BERWICK BANK WIND FARM

Subject: 00012342, 00012343, 00012344, 00012345 - Morven Offshore Wind Limited – Morven North Offshore Wind Array and Morven South Offshore Wind Array – EIA Section 36 Consent and Marine Licence Applications - Consultation – Response Required by 16 July 2026

Morven Offshore Wind Limited – Morven North Offshore Wind Array and Morven South Offshore Wind Array – EIA Section 36 Consent and Marine Licence Applications - Consultation Response Request.

Figure 1: Proposed development location shown on an airways chart

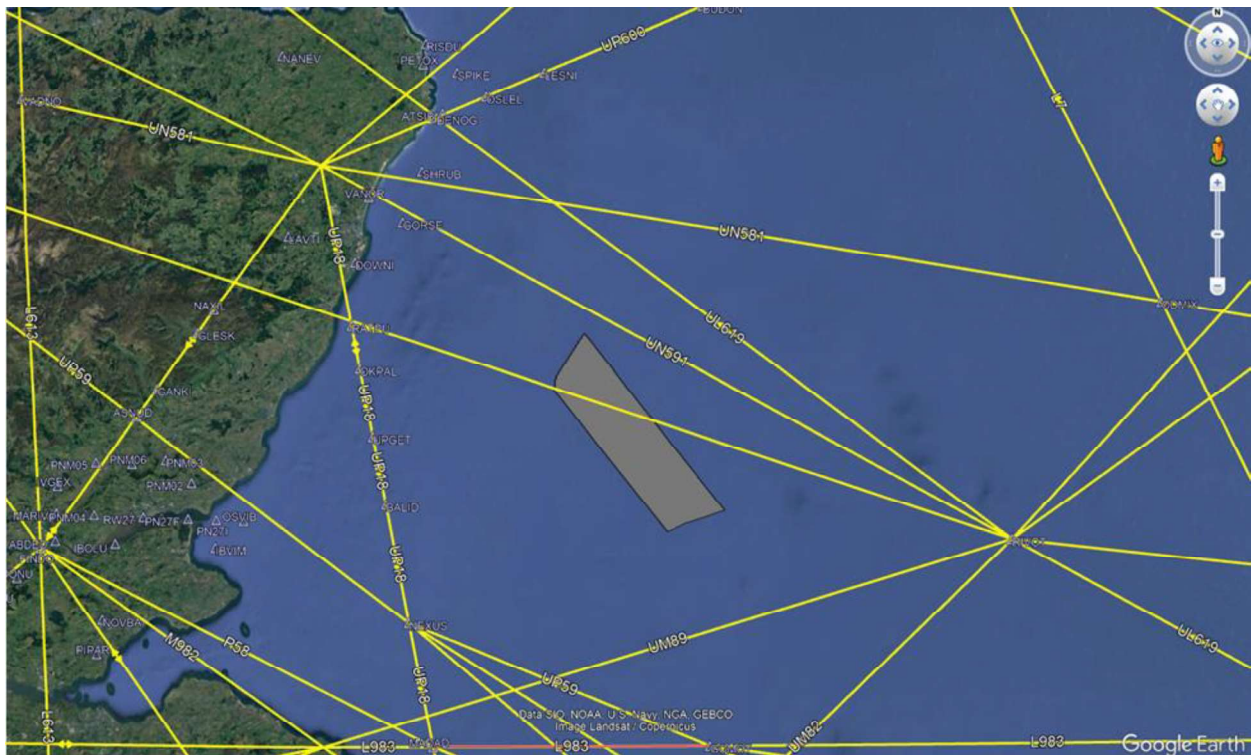
Unit or role	Comment
Prestwick Centre ATC	Unacceptable
Aberdeen ATC	Unacceptable
Military ATC	Unacceptable
